ADDENDUM TECHNICAL NOTE RELATING TO DRAINAGE STRATEGY

ROYSTON ROAD (SITE 13) BALDOCK BA4, HERTFORDSHIRE

CHALKDENE DEVELOPMENTS

RR-ISS-XX-XX-TN-C-3000

DRAWING TITLE:
PROPOSED DRAINAGE LAYOUT
OVERVIEW

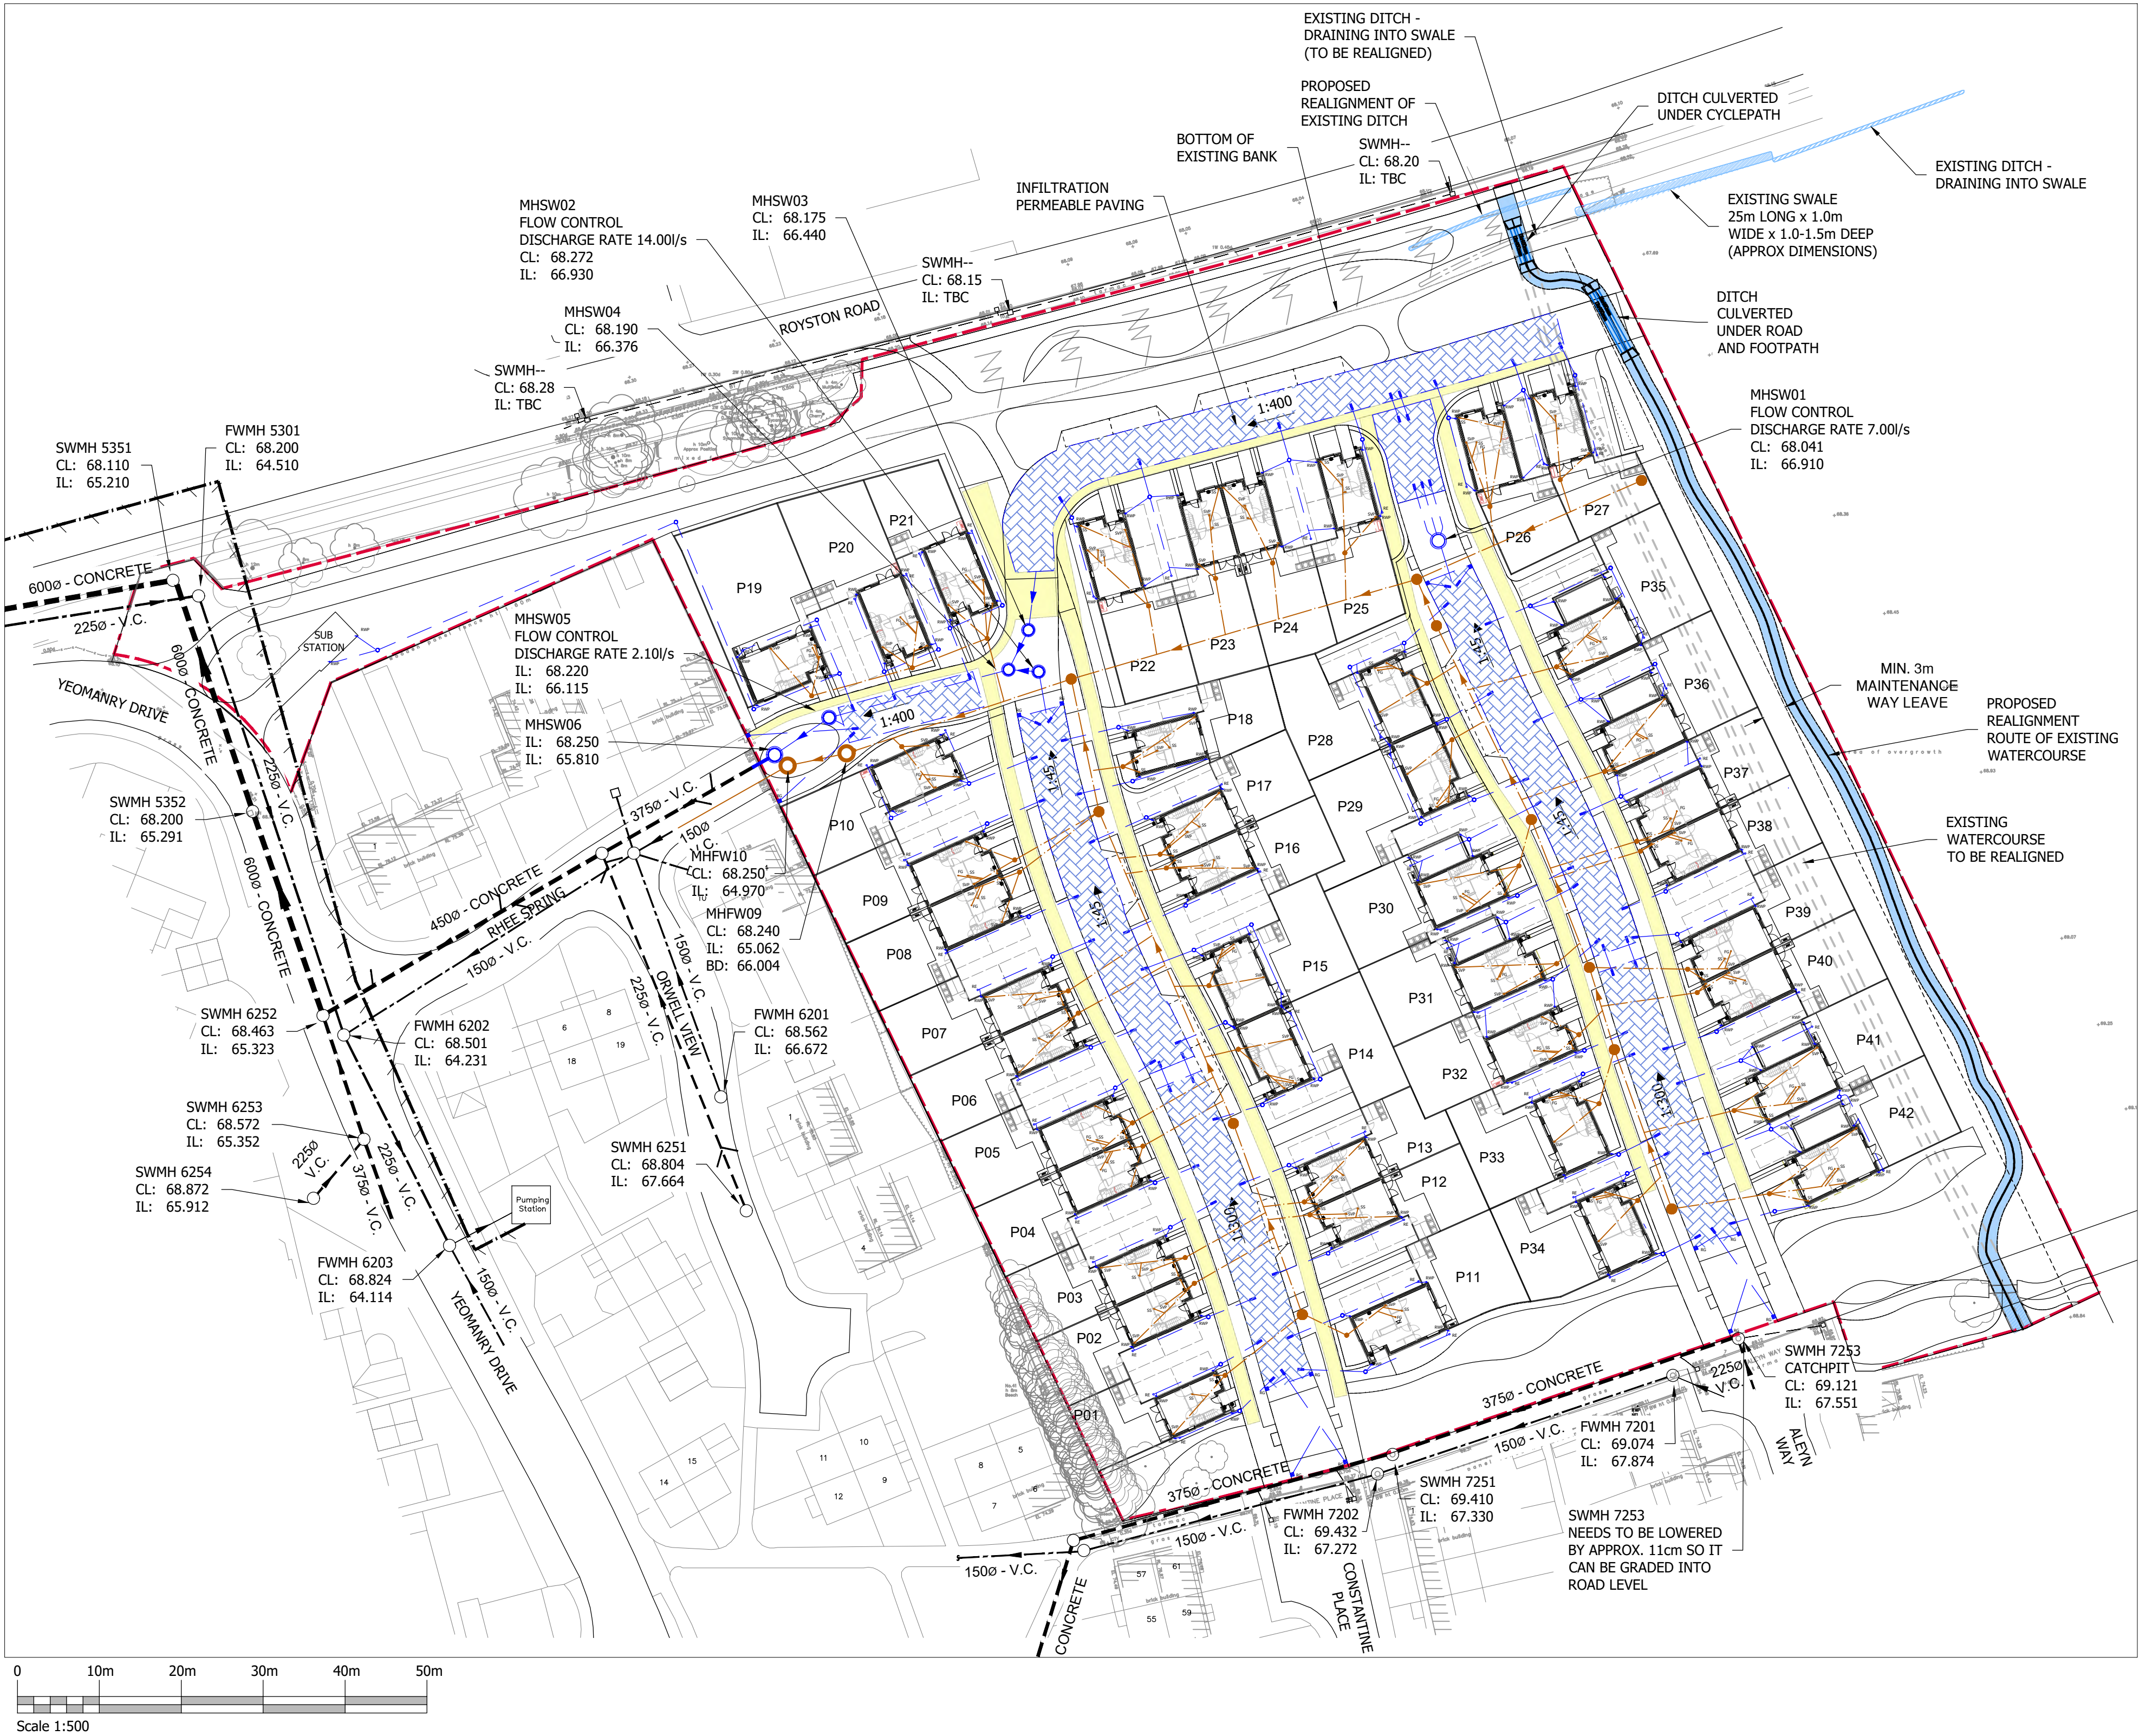
C04	12/03/26	GK/RJ	ARCHITECTS HARD LANDSCAPING PLAN UPDATED TO SHOW CORRECT REAR PATIO AREAS AND UPDATED WATERCOURSE LOCATION. NOTES AMENDED TO SUIT RE-ISSUED TO SUIT COMMENTS RECEIVED
C03	20/02/26	GK/RJ	SERVICE CORRIDOR HAS BEEN UPDATED TO SUIT LATEST M&E LAYOUT. TABLETOPS AT SOUTH OF SITE HAVE BEEN AMENDED TO SUIT GULLY POSITIONS
C02	18/02/26	GK/RJ	ISSUED FOR CONSTRUCTION
C01	30/01/26	GK/RJ

4.1 Gullies have added at the three connections to the public highway in order to intercept surface water run-off before it would discharge onto the public highway:

PROPOSED DRAINAGE LAYOUT
(SHEET 1 OF 3)

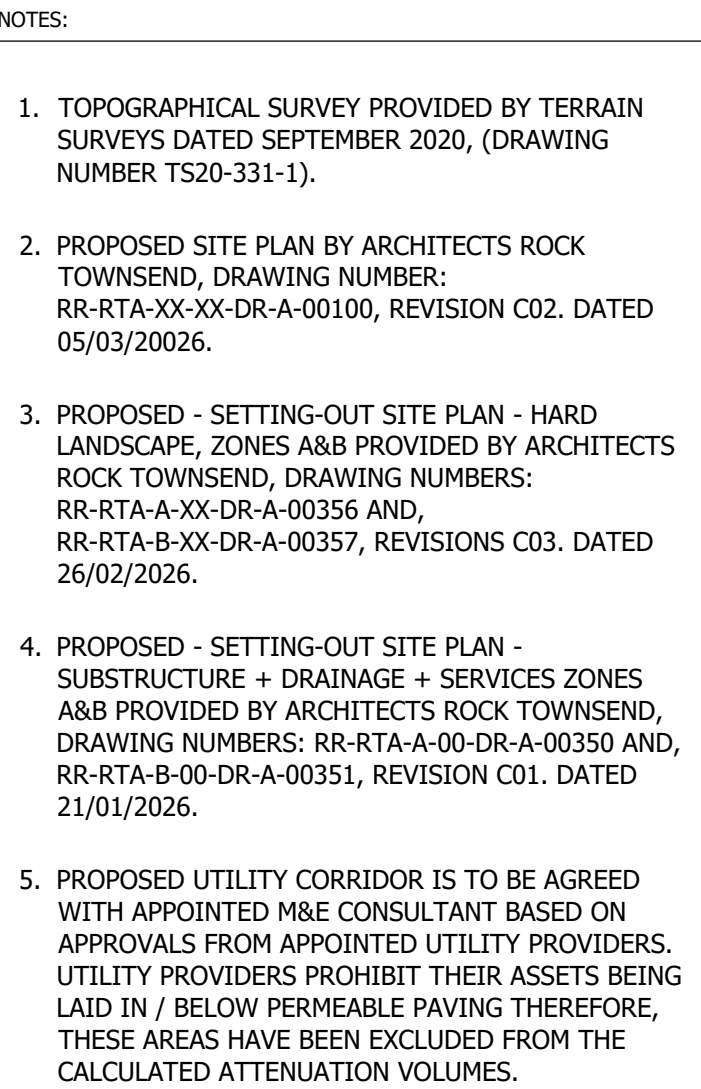
C04	12/03/26	GK/R	ARCHITECTS HARD LANDSCAPING PLAN UPDATED TO SHOW CORRECT REAR PATIO AREAS AND UPDATED WATERCOURSE LOCATION. NOTES AMENDED TO SUIT
C03	20/02/26	GK/R	EXISTING HEDGE FOR PLOT 19 ADDED AFTER REVIEW COMMENT(S) RECEIVED
C02	18/02/26	GK/R	PERMEABLE PAVING UNDER RAMPS OMITTED AND GULLIES ADDED AT SITE ACCESSES. SERVICE COVER LEVELS HAS BEEN UPDATED TO SUIT LATEST MAE LAYOUT. TABLETOPS AT SOUTH OF SITE HAVE BEEN AMENDED TO SUIT GULLY POSITIONS. MANHOLE COVER LEVELS HAVE BEEN AMENDED TO SUIT REVISED LEVELS
C01	30/01/26	GK/R	ISSUED FOR CONSTRUCTION
P13	05/12/25	GK/R	SITE PLAN UPDATED AND DRAINAGE AMENDED TO SUIT
P01	07/05/21	AS/R	ISSUED FOR INFORMATION
REV	DATE	DRAWN/CHK	REVISION INFO

DRAWING TITLE:
PROPOSED DRAINAGE LAYOUT
(SHEET 2 OF 3)

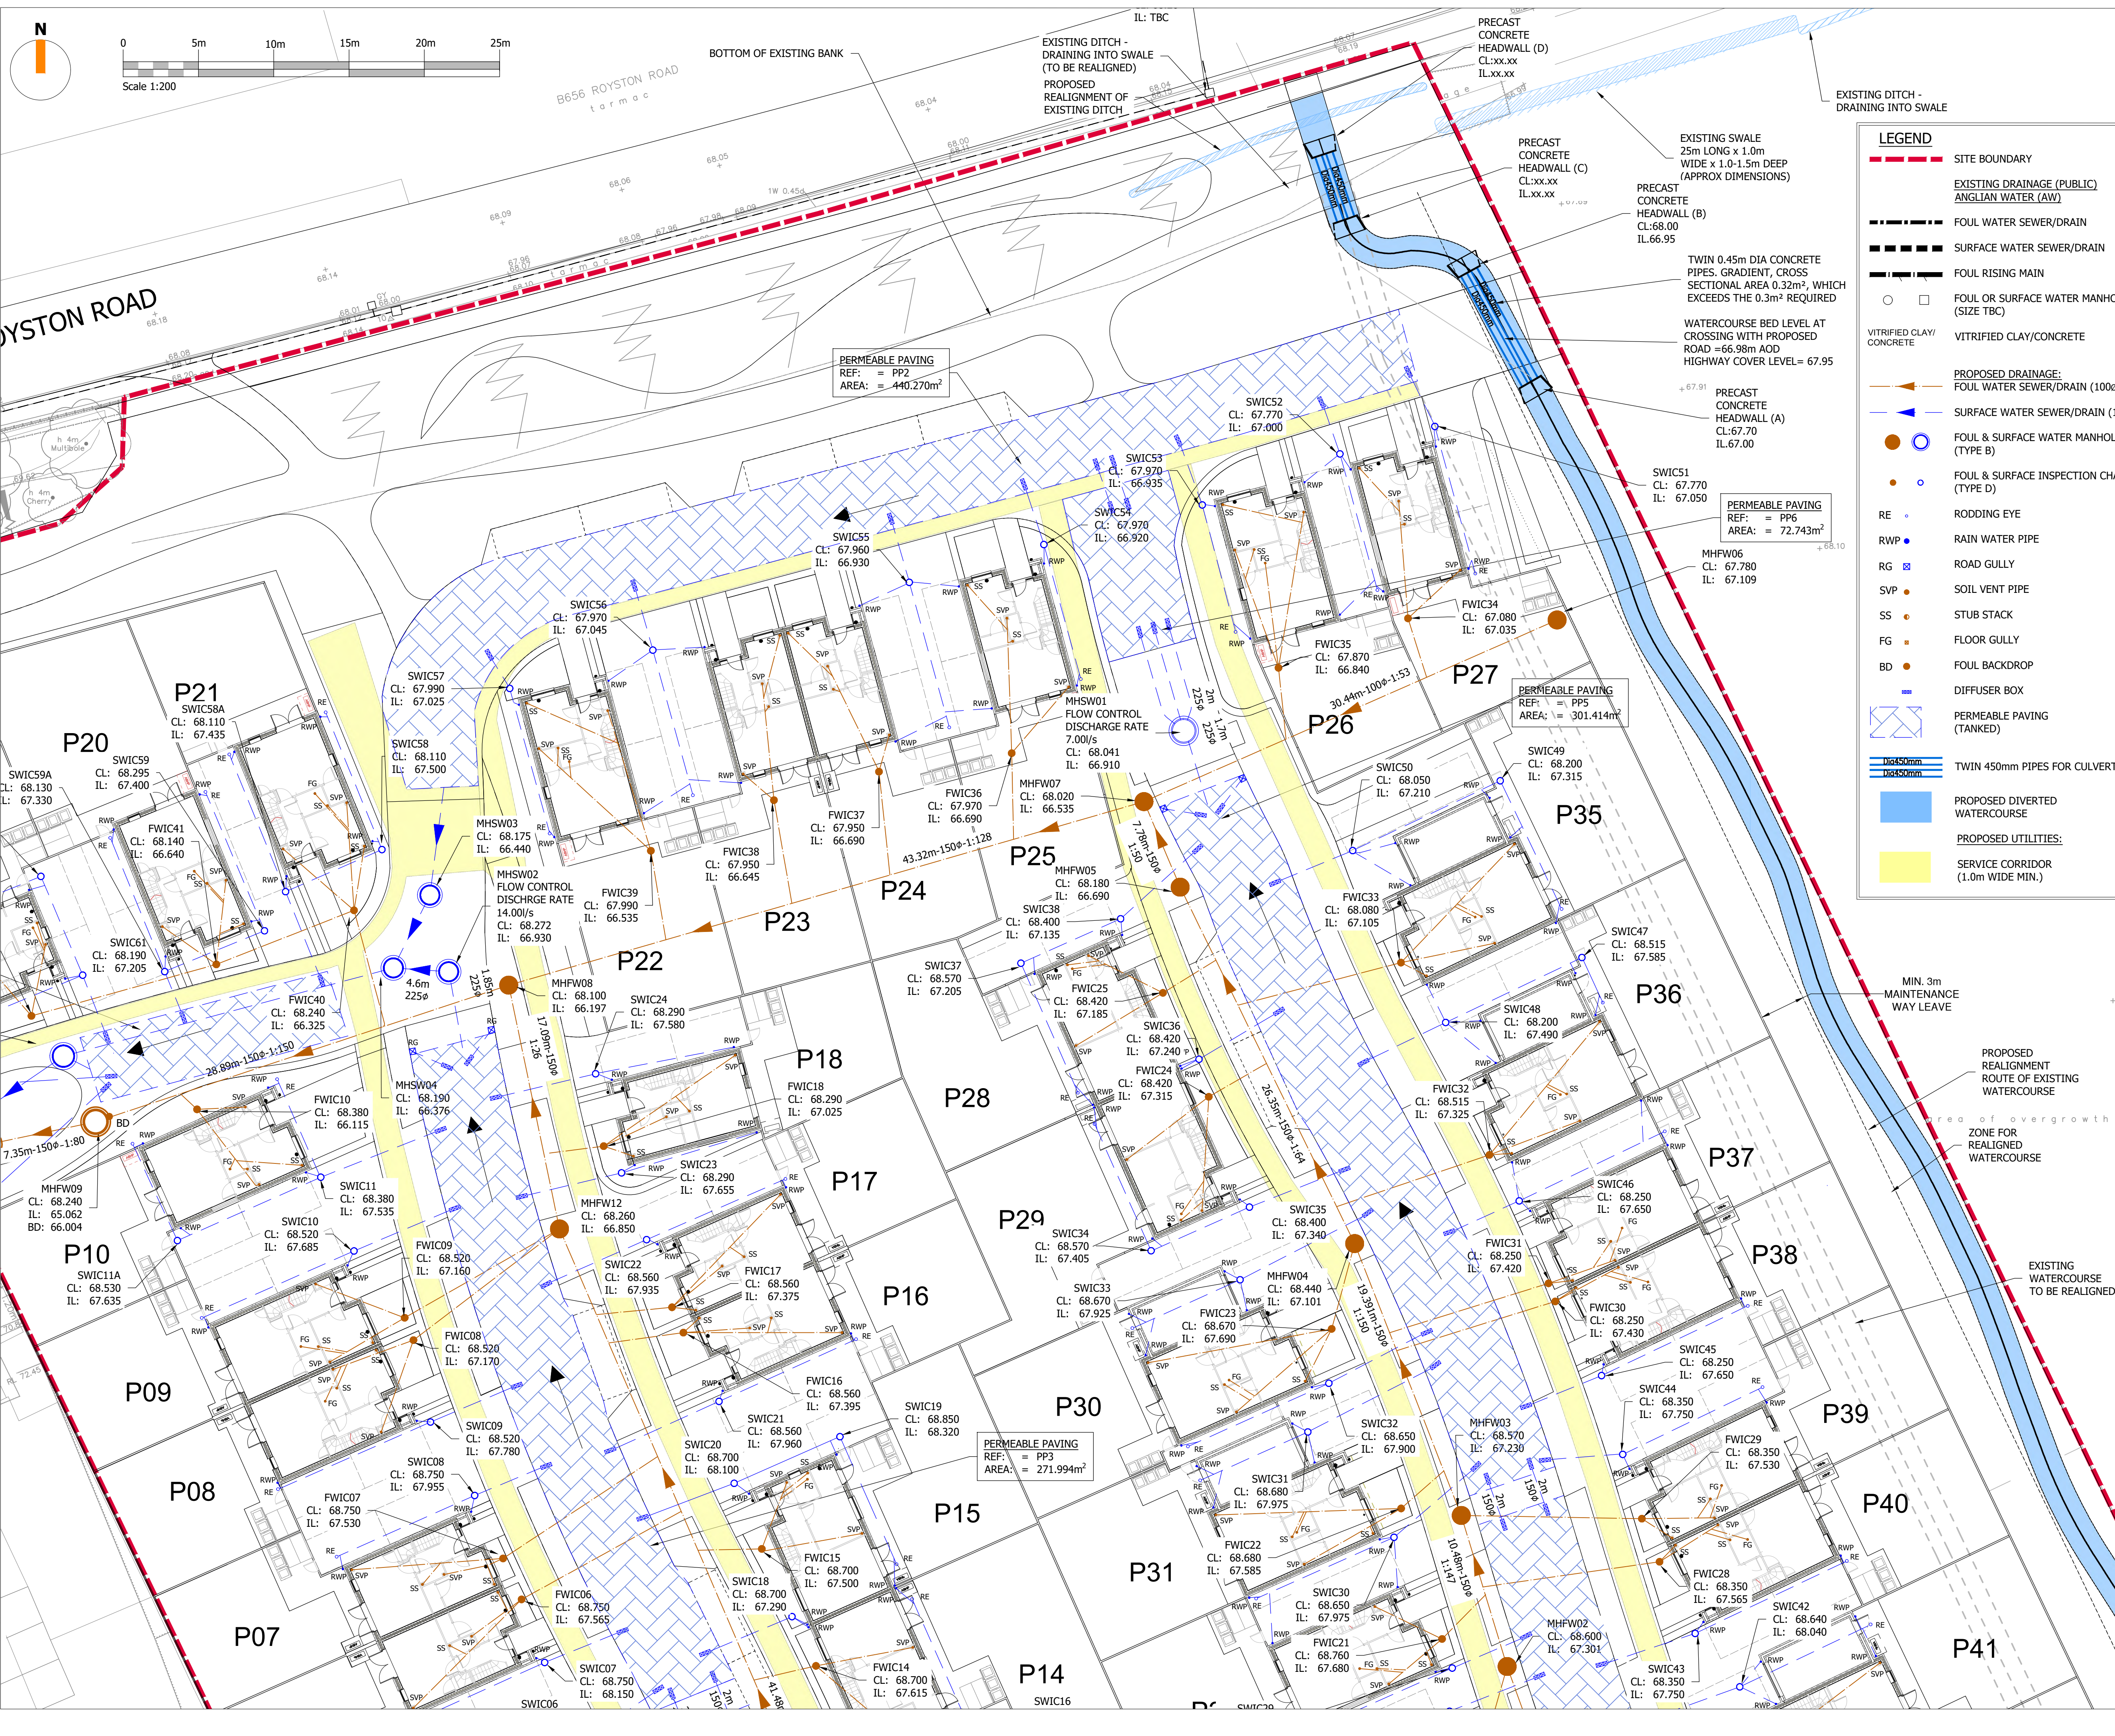
REV	DATE	DRAWN/CHK	REVISION INFO
C04	12/03/26	GK/RJ	ARCHITECTS HARD LANDSCAPING PLAN UPDATED TO SHOW CORRECT REAR PATIO AREAS AND UPDATED WATERCOURSE LOCATION. NOTES AMENDED TO SUIT.
C03	20/02/26	GK/RJ	DRAINAGE AND WATERCOURSE UPDATED AFTER REVIEWING COMMENTS RECEIVED.
C02	18/02/26	GK/RJ	PERMEABLE PAVING UNDER RAMPS OMITTED AND GULLIES ADDED AT SITE ACCESSES. SERVICE CORRIDOR HAS BEEN UPDATED TO SUIT LATEST M&E LAYOUT. TABLETOPS AT SOUTH OF SITE HAVE BEEN AMENDED TO SUIT GULLY POSITIONS. MANHOLE COVER LEVELS HAVE BEEN AMENDED TO SUIT REVISED LEVELS.
C01	30/01/26	GK/RJ	ISSUED FOR CONSTRUCTION.
P14	05/12/25	GK/RJ	SITE PLAN UPDATED AND DRAINAGE AMENDED TO SUIT.
P01	07/05/21	AS/RJ	ISSUED FOR INFORMATION.
